Subject: CERTIFICATE OF COMPLIANCE NO. 9292 FOR THE MODEL NO. PATRIOT PACKAGE: SUBMISSION of Response to Request for Additional Information (RAI) – DOCKET No. 71-9292; TAC No. L23770

Enclosure 1: RAI Questions and Westinghouse Responses

PATRIOT

Revision 1: April, 2005

Revised Partial Flooding Configuration

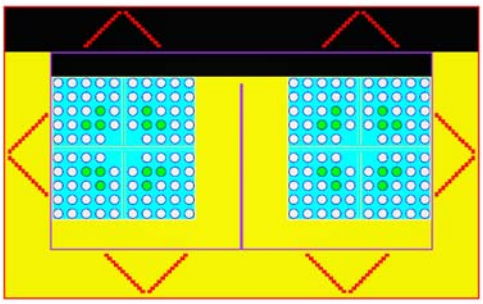
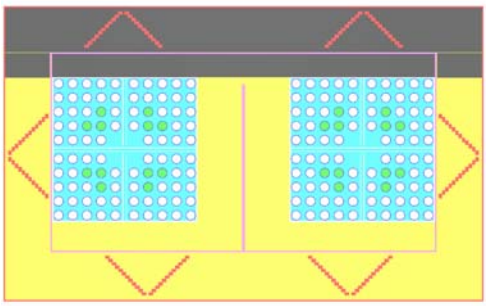
Justify the partial flooding configuration in the criticality analysis as the most reactive configuration of internal moderation.

Verify that the chosen partial flooding configuration is the most reactive, providing information in the RAI response that shows this and revising the FSAR criticality as needed.

The exact nature of this question had to do with the fact that the partial flooding configuration, shown in figure 6A-11 of the SAR and below, shows that there is water in the outer portion of the inner container that extends above the fuel assemblies. The NRC raised the question about the effect on k_{eff} of replacing that water with void.

Westinghouse took the most limiting case in the SAR and modified the input deck to add void to that area. The most limiting case corresponds to Run #6P-1-030 in table 6A-6. The results are given in the table below. They show that adding the void to that area results in a very slight increase in k_{eff}, still below the USL of 0.9343.

Run #	keff
6P-1-030	0.9285±0.0007
6P-1-030 with void at edge	0.9308±0.0007

Figure 6A-4 Typical 10x10 Assembly Design

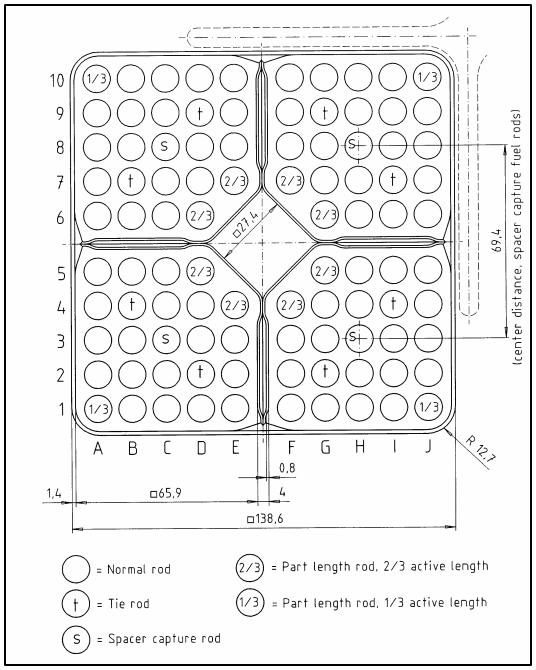
RAI ITEM 6-3.
Specify whether the fuel loadings contain partial length fuel rods or Gadolinia-Urania rods and the maximum number of each.

Clarification.
Describe in the proposed FSAR how fuel loading modeling was conservatively conducted to address partial loading.

The contents for which section 6A has been added to the SAR is a fuel bundle that contains twelve (12) partial length rods. Revision 1 to the SAR will revise Section 1.2.3, *Contents of Packaging*, to describe the new fuel bundle. An explanation follows.

The fuel bundle shown in figure 6A-4 contains four-1/3 length rods and eight-2/3 length rods. The 1/3 length rods are located on the outside corners of the bundle. The eight-2/3 length rods, two per mini-bundle, are located on the geometric diagonal toward the center of the bundle. The three new loading sets, #4 - #6, correspond to the upper, middle, and lower zones of the fuel bundle respectively. The criticality safety analysis was performed by analyzing each zone of the contents in its most conservative configuration as though it were a full length fuel bundle, thus bounding the actual fuel bundle.

The second assembly type, shown in figure 6A-4, is made up of four sub-assemblies with 24 rods in each sub-assembly. The assembly contains four-1/3 length rods and eight-2/3 length rods. The 1/3 length rods are located on the outside corners of the assembly. The eight-2/3 length rods, two per sub-assembly, are located on the geometric diagonal toward the center of the assembly. The three zones (upper, middle, and lower) of the assembly correspond to the fuel loading sets #4-#6 discussed in Section 6A.
